Access Compliance Report

Public Rights-of-Way

(Curb Ramps)

Intersection ID: 22096	Main Street: COLONY_RD	Cross Street: CARMEL_CRESCENT_DR	Location: NE
ADA ID: D08E8531FE2F	Ramp Type: PerpDiag	Initial Pass/Fail: Fail	Overall Compliance: No
Severity Score: 13.75			
Codes/Mitigation Info/Possible Solution		Field Measurements/Component Compliance

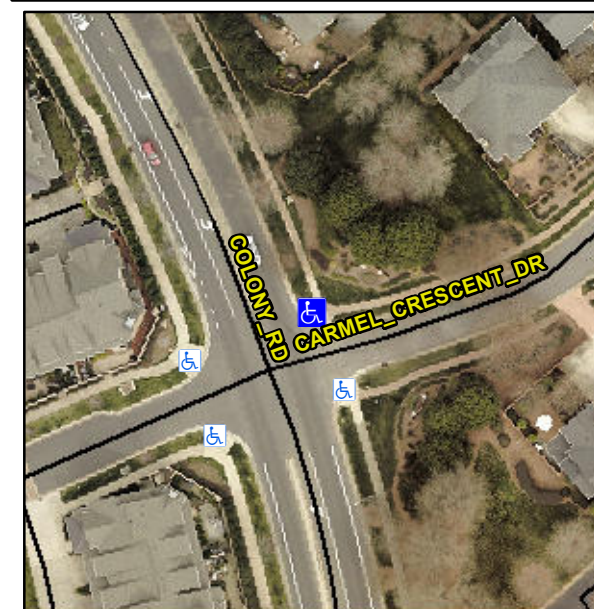
Not Found, R304.2.2, R304.5.3

Compliance	Description	Data	Compliance	Description	Data
N/A	Ramp Length (in)	97.0	No	Ramp Slope (%)	8.4
Yes	Ramp Width (in)	52.0	No	Ramp XSlope (%)	2.6
N/A	Flare Type LT	N/A	N/A	Flare Type RT	N/A
N/A	Flare Slope LT (%)	N/A	N/A	Flare Slope RT (%)	N/A
N/A	Flare Traversable LT?	N/A	N/A	Flare Traversable RT?	N/A
N/A	Landing Length (in)	N/A	N/A	DWS Provided?	N/A
N/A	Landing Width (in)	N/A	N/A	DWS Contrast?	N/A
N/A	Landing Slope (%)	N/A	N/A	DWS Length (in)	N/A
N/A	Landing X Slope (%)	N/A	N/A	DWS Full Width?	N/A
N/A	Landing Curb? (Y/N)	N/A	N/A	DWS Offset (in)	N/A
N/A	Shared Landing?	N/A			
N/A	Gutter Ponding?	N/A	N/A	Gutter Slope (%)	N/A
N/A	Gutter Lip Ht (in)	N/A	N/A	Gutter X Slope (%)	N/A
N/A	Painted X Walk1?	No	N/A	Painted X Walk2?	No
	X Walk 1 Direction	To W		X Walk 2 Direction	To S
N/A	X Walk 1 Width (in)	N/A	N/A	X Walk 2 Width (in)	N/A
	X Walk 1 Slope (%)	0.7		X Walk 2 Slope (%)	3.6
	X Walk 1 X Slope (%)	5.2		X Walk 2 X Slope (%)	0.8

Remove & Replace Curb Ramp With Two New Directional Ramps or Equivalent.
